# Access Compliance Report

## Public Rights-of-Way

Intersection ID: 31809	Main Street: CRANE_POINT_DR	Cross Street: OSPREY_WATCH_CT	Location: SE
ADA ID: B963A8D63115	Ramp Type: PerpDiag	Initial Pass/Fail: Fail	Overall Compliance: No
Severity Score: 8.75			
Codes/Mitigation Info/Possible Solution		Field Measurements/Component Compliance

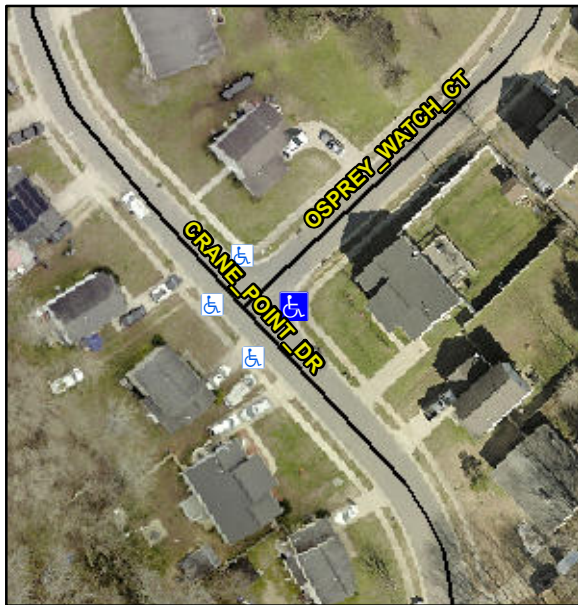
**Not Found, R304.5.1**

Compliance	Description	Data	Compliance	Description	Data
N/A	Ramp Length (in)	47.0	Yes	Ramp Slope (%)	5.1
No	Ramp Width (in)	44.0	Yes	Ramp XSlope (%)	0.5
N/A	Flare Type LT	N/A	N/A	Flare Type RT	N/A
N/A	Flare Slope LT (%)	N/A	N/A	Flare Slope RT (%)	N/A
N/A	Flare Traversable LT?	N/A	N/A	Flare Traversable RT?	N/A
N/A	Landing Length (in)	N/A	N/A	DWS Provided?	N/A
N/A	Landing Width (in)	N/A	N/A	DWS Contrast?	N/A
N/A	Landing Slope (%)	N/A	N/A	DWS Length (in)	N/A
N/A	Landing X Slope (%)	N/A	N/A	DWS Full Width?	N/A
N/A	Landing Curb? (Y/N)	N/A	N/A	DWS Offset (in)	N/A
N/A	Shared Landing?	N/A			
N/A	Gutter Ponding?	N/A	N/A	Gutter Slope (%)	N/A
N/A	Gutter Lip Ht (in)	N/A	N/A	Gutter X Slope (%)	N/A
N/A	Painted X Walk1?	No	N/A	Painted X Walk2?	No
	X Walk 1 Direction	To NW		X Walk 2 Direction	To SW
N/A	X Walk 1 Width (in)	N/A	N/A	X Walk 2 Width (in)	N/A
	X Walk 1 Slope (%)	2.3		X Walk 2 Slope (%)	2.4
	X Walk 1 X Slope (%)	2.0		X Walk 2 X Slope (%)	2.9

**Remove & Replace Curb Ramp With Two New Directional Ramps or Equivalent.**
